Comments Regarding Draft Environmental Impact Statement for Combined Licenses (COLs) for
Comanche Peak Nuclear Power Plant Units 3 and 4

By David Power
Public Citizen's Texas Office

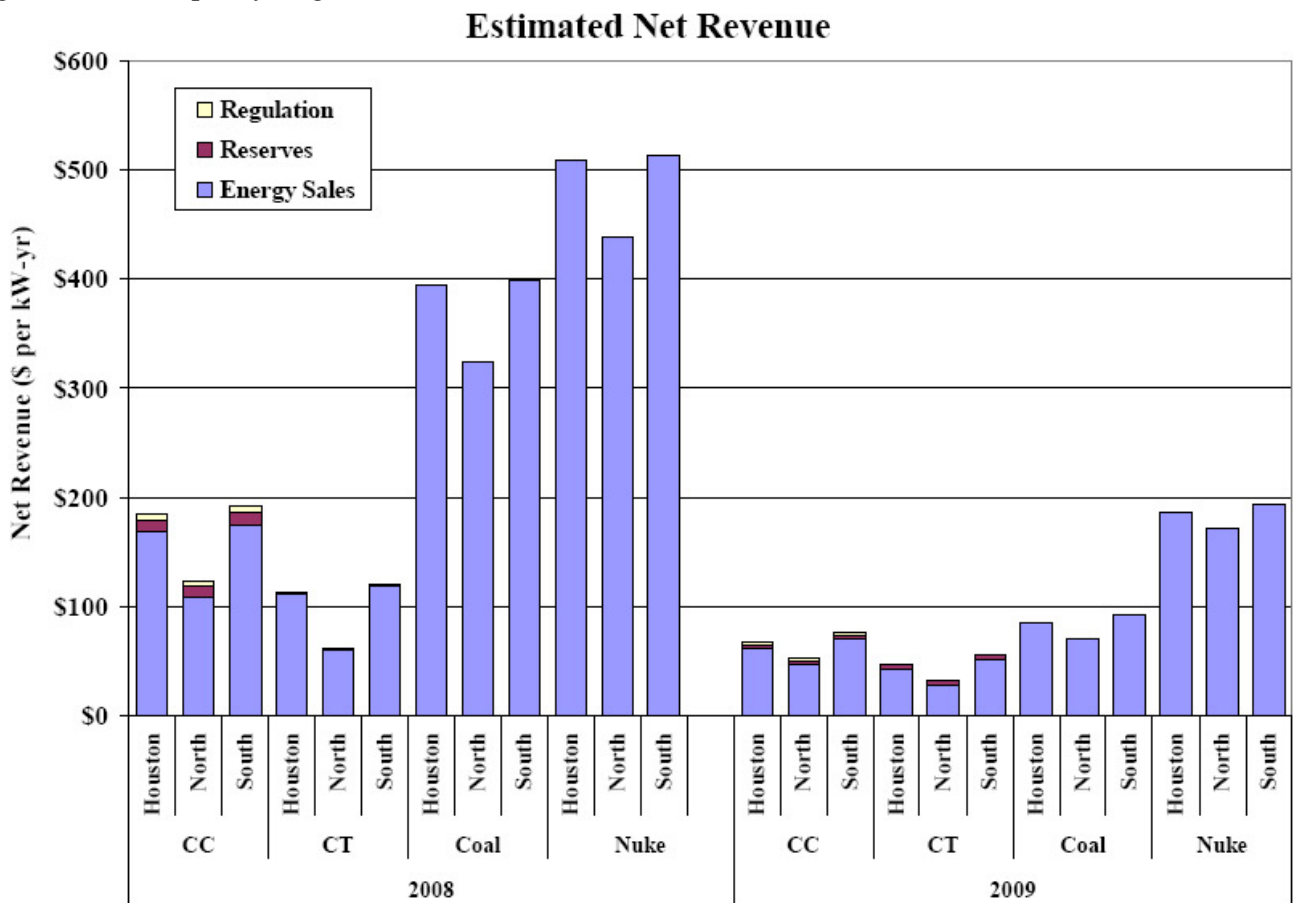
The figure above shows that the net revenue decreased substantially in 2009 compared to each zone compared in 2008. Based on our estimates of investment costs for new units, the net revenue required to satisfy the annual fixed costs (including capital carrying costs) of a new gas turbine unit ranges from \$70 to \$95 per kW-year. The estimated net revenue in 2009 for a new gas turbine was approximately \$55, \$47 and \$32 per kW-year in the South, Houston and North Zones, respectively. For a new combined cycle unit, the estimated net revenue requirement is approximately \$105 to \$135 per kW-year. The estimated net revenue in 2009 for a new combined cycle unit was approximately \$76, \$67 and \$52 per kW-year in the South, Houston and North Zones, respectively.

These values indicate that the estimated net revenue in 2009 was well below the levels required to support new entry for a new gas turbine or a combined cycle unit in the ERCOT region. Prior to 2005, net revenues were well below the levels necessary to justify new investment in coal and nuclear generation. However, high natural gas prices through 2008 allowed energy prices to remain at levels high enough to support new entry for these technologies. The production costs of coal and nuclear units did not change significantly over this period, leading to a dramatic rise in net revenues. With the significant decline in natural gas and energy prices in 2009, these results changed dramatically from recent years. For a new coal unit, the estimated net revenue requirement is approximately \$190 to \$245 per kW-year. The estimated net revenue in 2009 for a new coal unit was approximately \$93, \$84 and \$70 per kW-year in the South, Houston and North Zones, respectively. For a new nuclear unit, the estimated net revenue requirement is approximately \$280 to \$390 per kW-year. The estimated net revenue in 2009 for a new nuclear unit was approximately \$194, \$187 and \$172 per kW-year in the South, Houston and North Zones, respectively. These values indicate that the estimated net revenue for a new coal and nuclear unit in the South, Houston and North Zones was well below the levels required to support new entry in 2009. “ This calls into question the validity of the NRC staff’s determination on 8-1 line 43 that market conditions justify Luminant’s proposal.

An example of monthly incremental electrical energy provided by various TIC options for a 316-MW Cogeneration system in Pasadena, TX (Punwani 2001)⁸

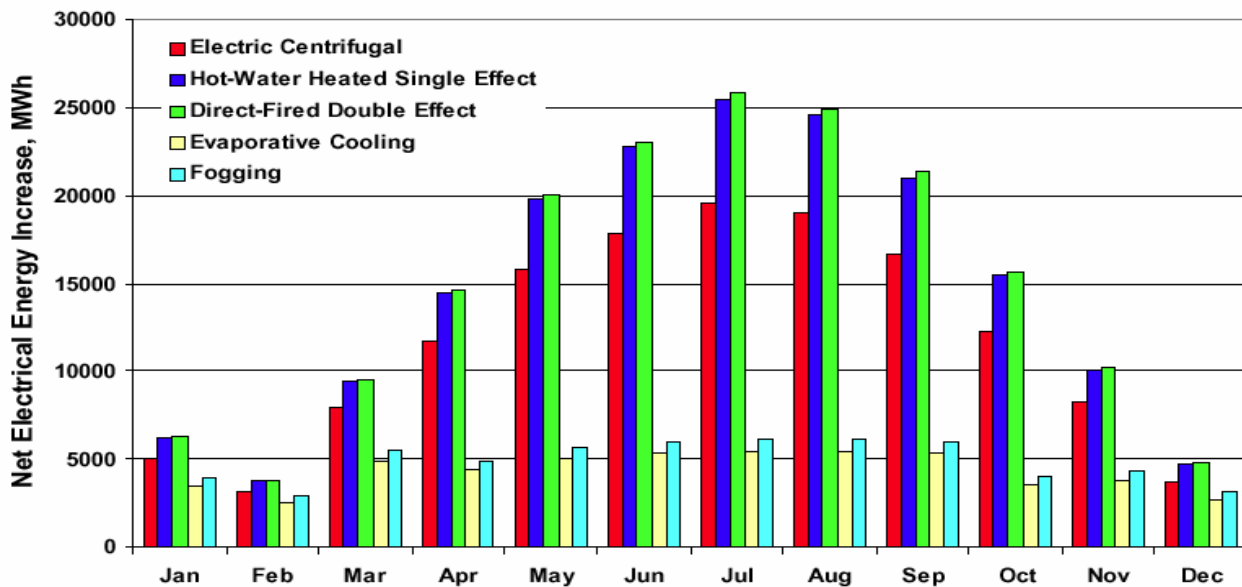
Adding Turbine inlet cooling (TIC) can provide significant increase in energy during the peak load months when it's needed while reducing emissions for a low cost. A national study showed that the reduction in capacity exceeded 29,000 MW in the summer months⁹, on average, that could be restored by proper application of this technology. The hot southern states have a greater impact in reduction due to climate conditions of this sort.
